## RECOMMENDATION MEETING

# 101 John Street

**PROJECT ADDRESS:** 101 JOHN STREET, SEATTLE, WA  
**MUP:** 3010551      **DATE:** MAY 07, 2014      **PAGE:** 01

## COURTYARD DESIGN

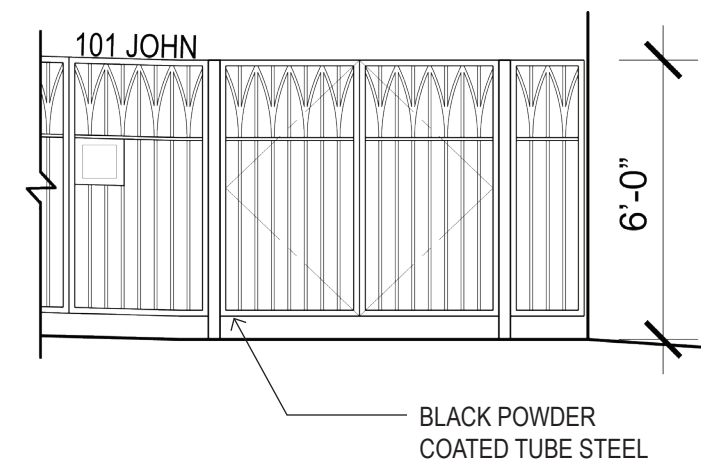
At the Early Design Guidance Meeting, the Board was pleased with the proposed courtyard space, but warned that the design of this space should consider the lack of solar exposure. It is likely that an interesting hardscape design, rather than a heavily landscaped design would make sense given this condition. Interesting paving, furniture and exterior lighting (under lit benches, catenary lighting, etc) that highlights the hardscape elements and add light and life to the courtyard are strongly encouraged.

The project team has created a courtyard design that is a mixture of landscape and hardscape elements including seating areas and raised planters. The Landscape Architect has specified plantings, green walls, and other vegetative material that thrives in low-level light conditions. Catenary and other lighting elements will further enliven the courtyard.

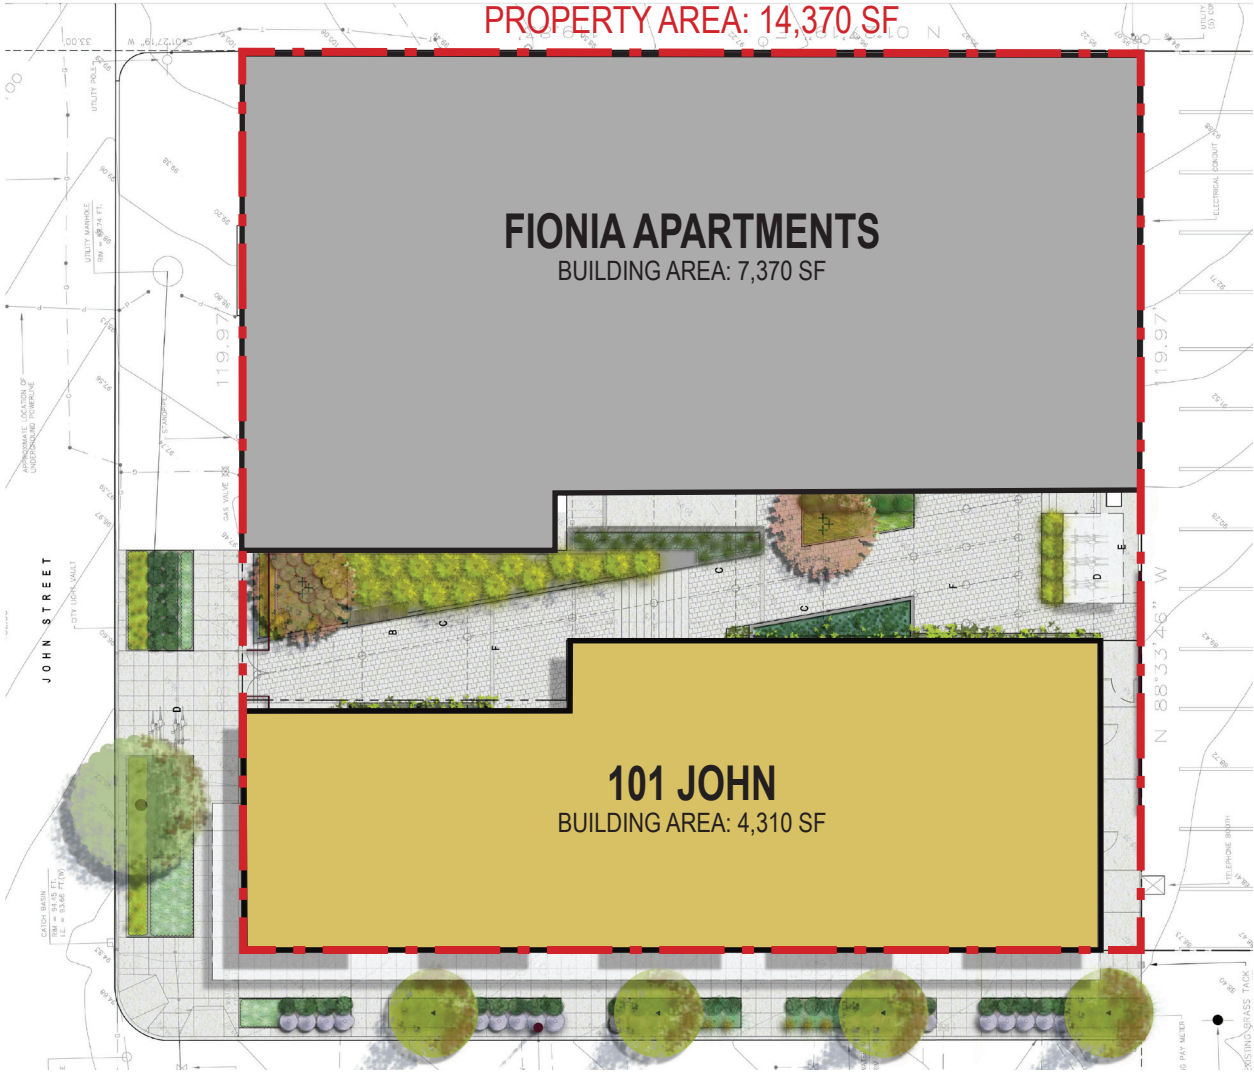
The original approach to calculating Green Factor requirements followed the interpretation of DR 10-2011 (B) (2), which states that a “...Green Factor ‘parcel size’ can be based on the new construction’s impact area...” Green Factor calculations based on the impact area alone (+/-7,000 sf) would result in a factor that is twice that of the site as a whole (.408 - well beyond the .30 required). This is due to the fact that there is a generous amount of streetscape planting on two frontages of the new building, as well as within the courtyard between the new and existing structure. These combined areas provide multiple visual and environmental benefits (including storm water attenuation) at the ground level. These benefits extend to passersby and users of the retail frontage, as well as residents who can enjoy access to and birds-eye views of the new courtyard.

With the entire property area being used to determine the Green Factor, approximately 3700 sf of green roof would be required to meet the .30 Green Factor. For cost and structural design reasons, this would be a thin, 2” to 4” profile (extensive) system, planted primarily with sedum and other low-growing plants. An extensive green roof would provide some storm water and other environmental functions, but would lack the aesthetic qualities and multiple benefits of shade, vertical relief, and seasonal/textural interest that can be enjoyed at-grade. It is felt that from a cost-benefit perspective, there is greater overall value by providing at-grade features that contribute to the vibrancy of the streetscape and neighborhood, such as a well-planted streetscape and a courtyard with catenary lighting, shade gardens, storm water planters and vertical trellis structures for vines.
